# UNITED STATES PATENT AND TRADEMARK OFFICE

APPLICATION NO.	FILING DATE	FIRST NAMED INVENTOR	ATTORNEY DOCKET NO.	CONFIRMATION NO.
10/753,094	01/07/2004	Robert K. Kopras	035568-0122	2746
26371	7590	11/25/2005		
FOLEY & LARDNER LLP 777 EAST WISCONSIN AVENUE SUITE 3800 MILWAUKEE, WI 53202-5308			EXAMINER CADUGAN, ERICA E	
			ART UNIT	PAPER NUMBER
			3722

**Office Action Summary**

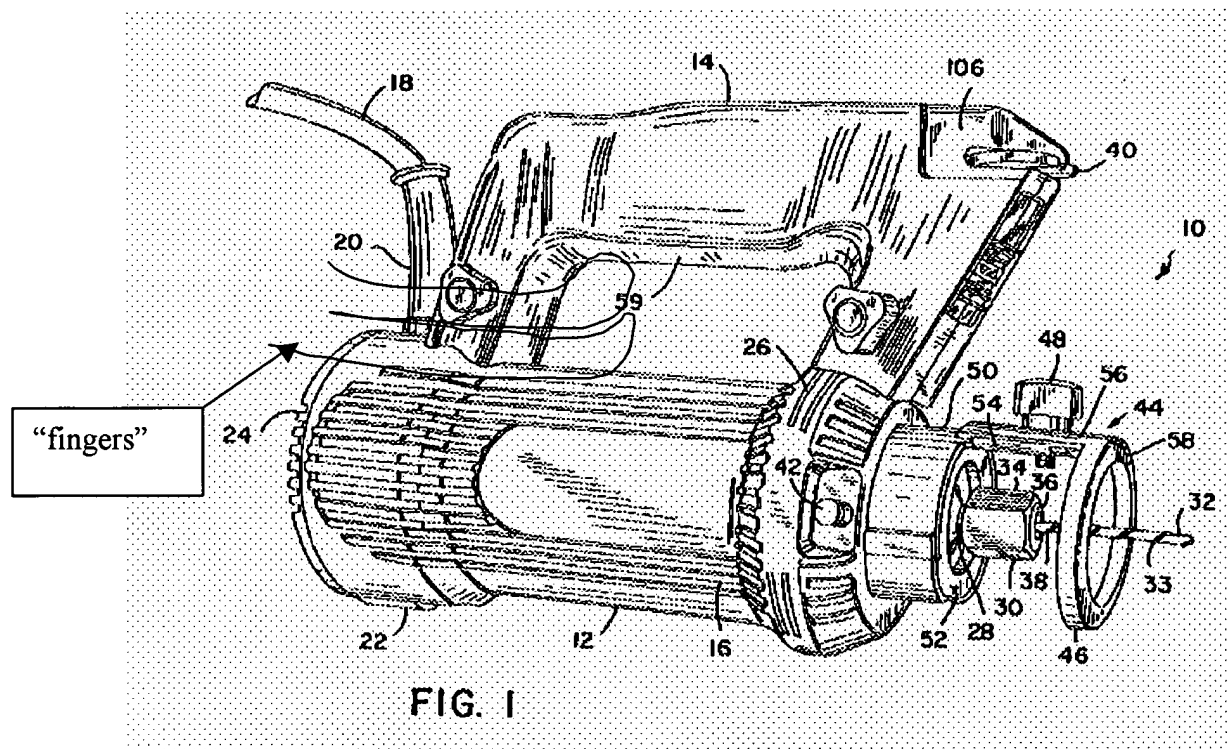
Kopras teaches a handle 14 attachment that is selectively attachable to a housing 12 of a rotary cutting tool (see Figure 1). Note that the handle 14 is substantially perpendicular to the central longitudinal axis (such central longitudinal axis extending generally horizontally as viewed in Figure 1) of the tool when attached thereto, as viewed, for example, from either of the left or right ends (left or right are as viewed in Figure 1).

Additionally, re independent claim 15, note that any of the surfaces of the handle 14 that are exposed when the handle 14 is attached to the housing 12 are available to be gripped by a user, and thus, as broadly claimed, are considered to be “gripping surfaces”. See, for example, the reproduction of Figure 1 below, wherein Examiner has shown the location of “fingers” in a possible gripping location/configuration. Thus, the handle includes “gripping surfaces” that are “substantially perpendicular” (i.e., more perpendicular than not) to the central longitudinal axis of the rotary cutting tool when the handle is attached to the tool (see Figure 1, for example).
